**SUPPLEMENTAL
GEOTECHNICAL INVESTIGATION
SR-167 HOV LANES, STAGE I
KING COUNTY, WASHINGTON**

HWA Project No. 91101-2

May 21, 1993

RESPONSE TO WSDOT REVIEW COMMENTS

SITE & EXPLORATION PLAN
84th AVE. S. INTERCHANGE
DR1 RAMP

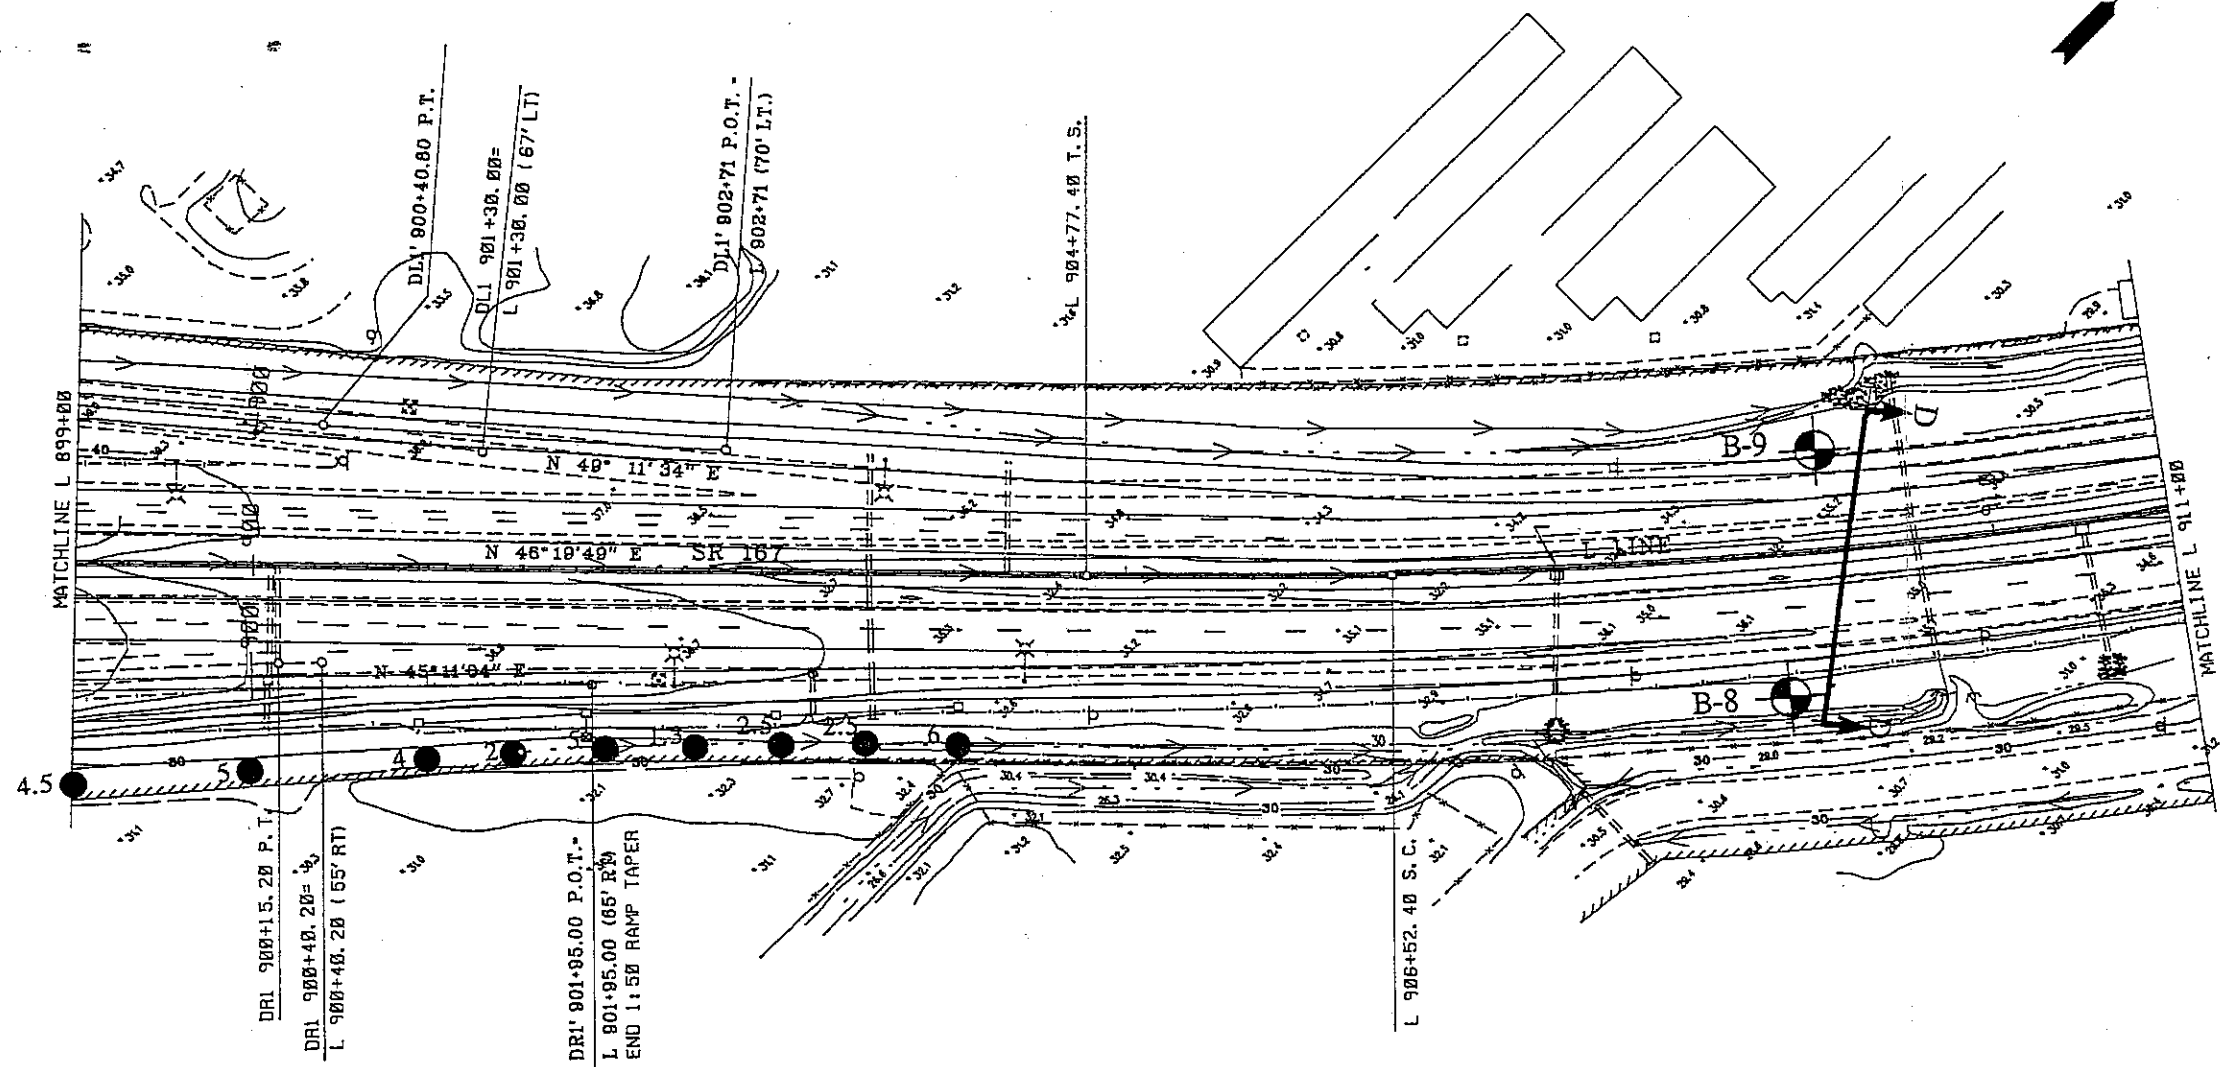
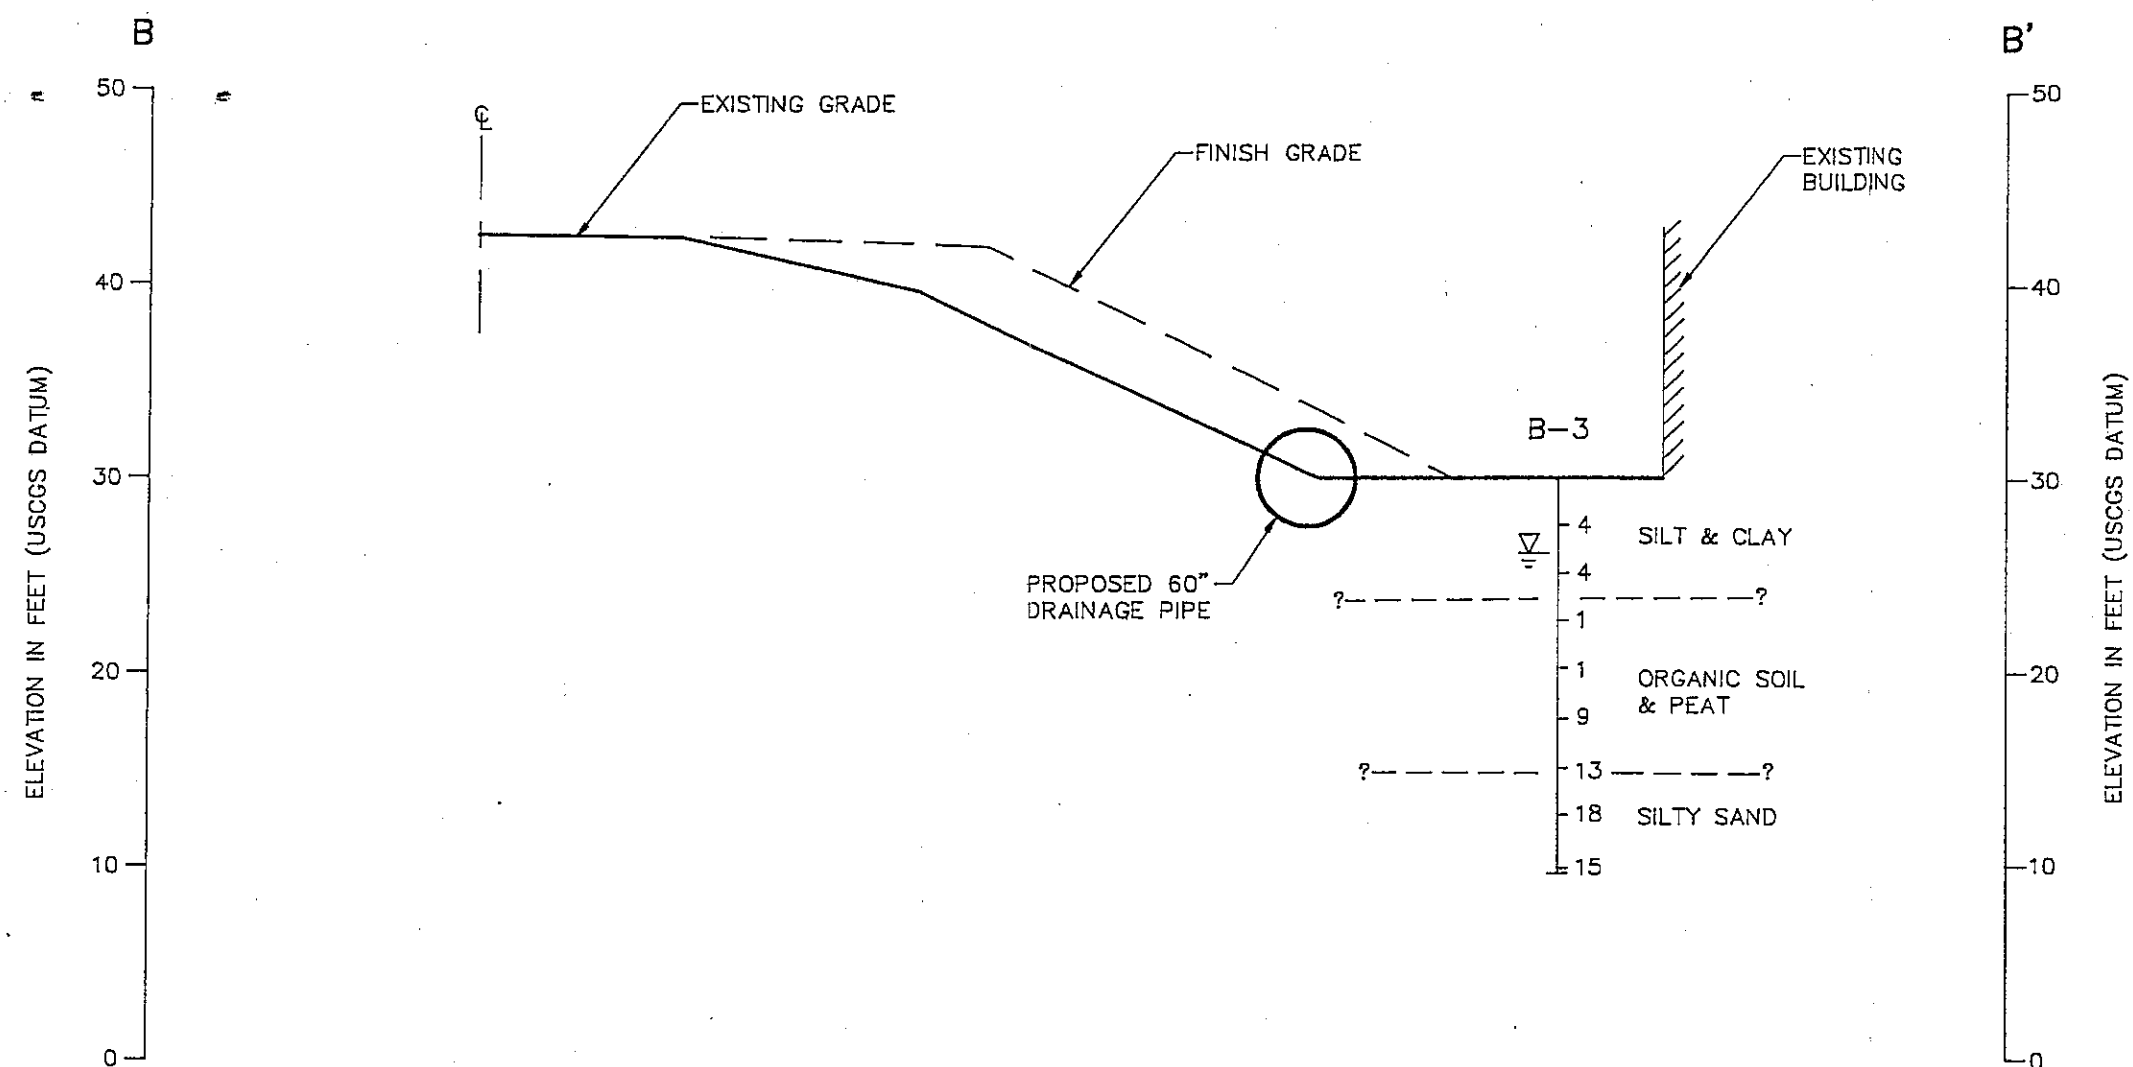
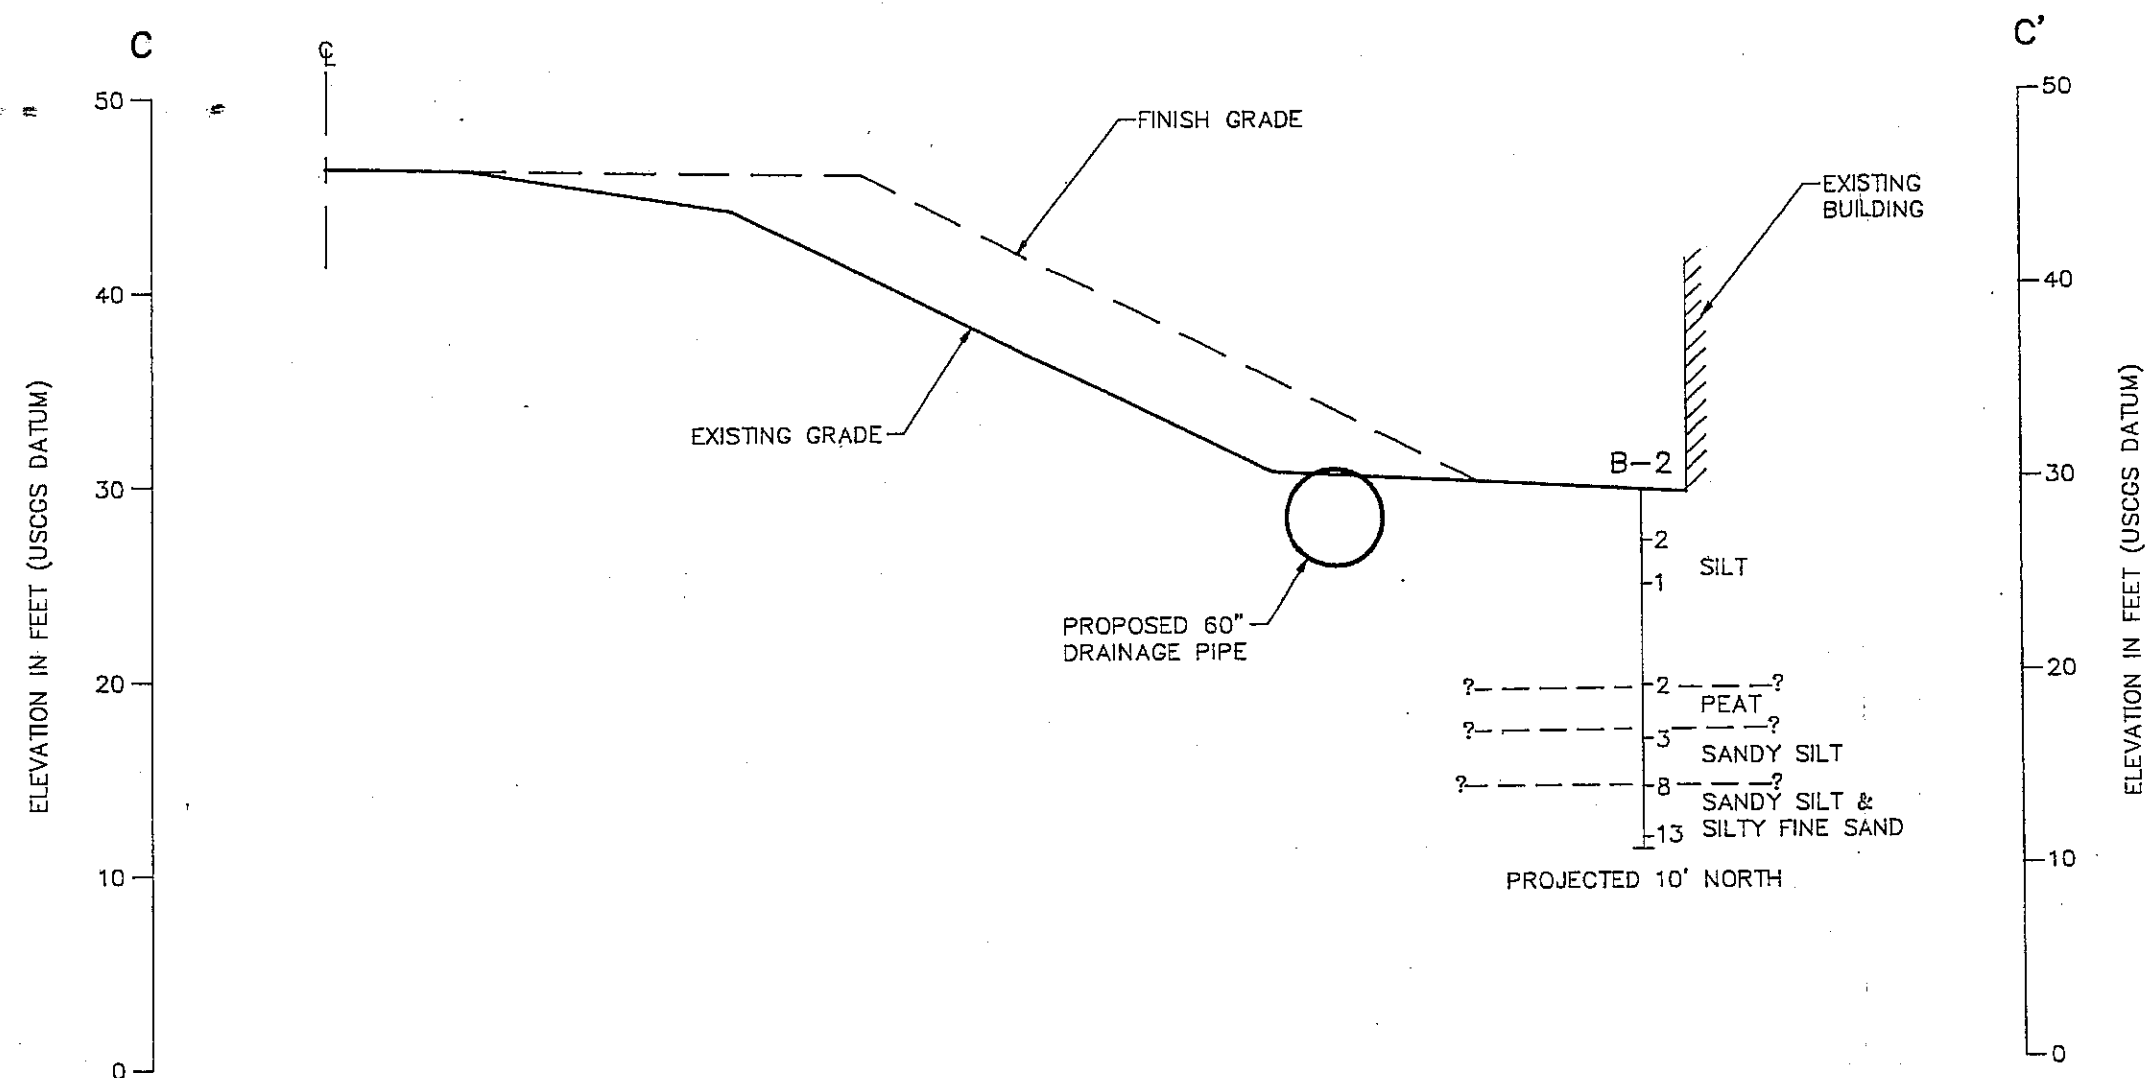
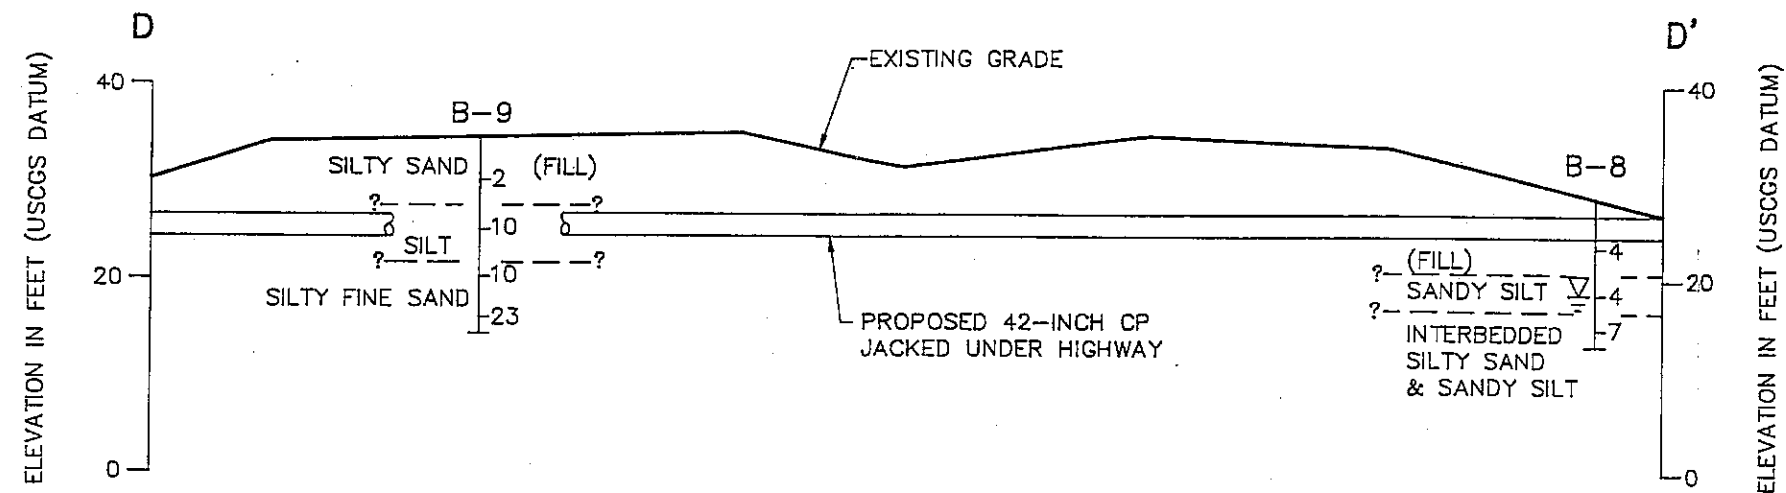
HWA describes the settlement related to the preload, but neglects to account for the effects of the excavation of the 60 inch diameter pipe. This excavation will occur in identified areas of peat. What are the recommendations to prevent movement of the peat and the potential impacts to the adjacent buildings? Please provide a discussion of options.
